ITEM VI-A: MAJOR PROJECT PERMIT MODIFICATION (STAGE ONE) & MAJOR PROJECT PERMIT (STAGE TWO) – 1151 GALLERIA BOULEVARD (NCRSP PARCEL 35 – GALLERIA MALL EXPANSION) -- FILE# MPPMOD 95-01A & MPP 04-02.

REQUEST

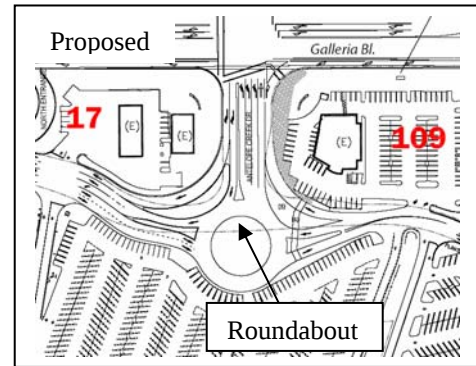
- *Antelope Creek Drive / Galleria Circle* – The current configuration at this location is a “T” intersection with free-flowing left and right turning movements for inbound traffic entering from Galleria Boulevard (see Attachment 2). During peak traffic events (typically Saturday afternoons and holidays), the free-flowing left turn movement often results in delays for motorists attempting to make a left turn onto Antelope Creek Drive to exit the mall. This delay often results in a long queue. One solution to this queuing problem is to restrict the left-turning movements for vehicles inbound from Galleria Boulevard. However, this solution is undesirable, as it limits turning movements to rights only, which alters the dispersion of trips entering from Galleria Boulevard.

To maximize efficiency of the intersection while maintaining turning movements, a two-lane roundabout has been designed. The roundabout allows for the continuous movement of vehicles, while maintaining turning movements in all directions. The roundabout will be designed with metering signals that, during peak events, will further meter the flow of traffic into the roundabout. The meters will ensure that the roundabouts do not clog as a result of the vehicle queue caused by the traffic signal at Galleria Boulevard. It is expected that the metering signals will only be necessary during peak times.

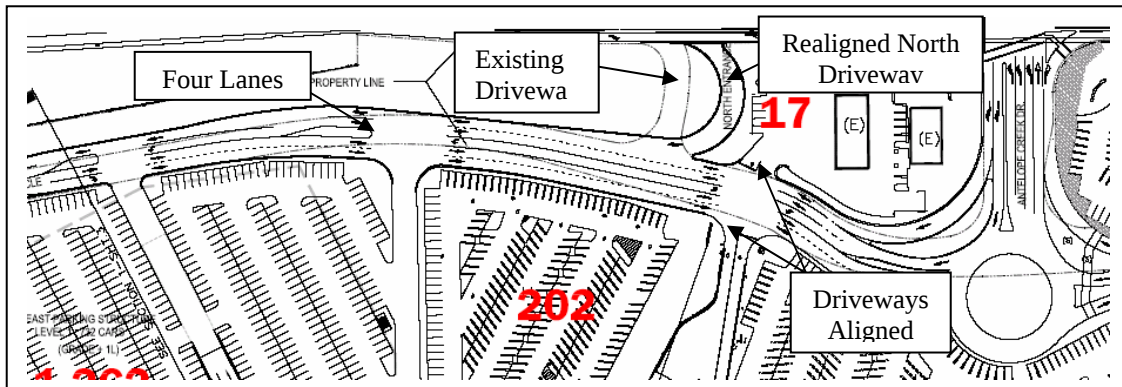
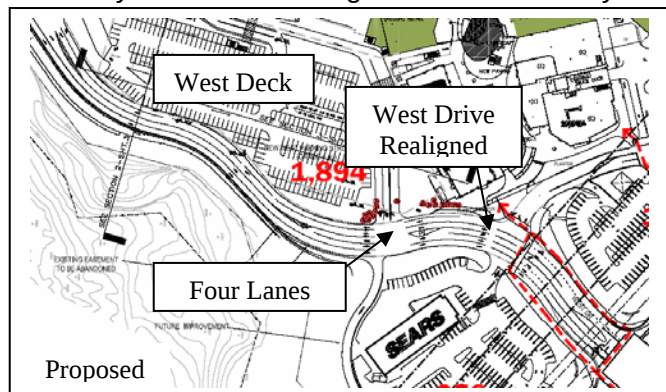
- **Northern Galleria driveway** – The northern Galleria Boulevard driveway is a one-way entrance from Galleria Boulevard that allows left- and right-turning movements on Galleria Circle. Similar to the main entrance, the left-turning movements at the northern driveway result in a queue for vehicles heading northbound (toward Macy's) on the ring road. Elimination of the left-turning movement will eliminate the need for a northbound stop sign at this location, thus eliminating the queue in both directions. In addition, this driveway will be lengthened and slightly realigned to create more deceleration distance and better visibility for vehicles exiting Galleria Boulevard and merging with ring road traffic.

- **Ring Road (Galleria Circle)** – The segment of Galleria Circle from the proposed roundabout to the proposed grade-plus-one level parking deck (East Deck) will be widened to four lanes, plus a center left turn lane. This will provide additional outbound capacity for vehicles exiting the East Deck. Both outbound lanes will feed into the two-lane roundabout, which will increase outbound capacity at the Antelope Creek Drive exit.
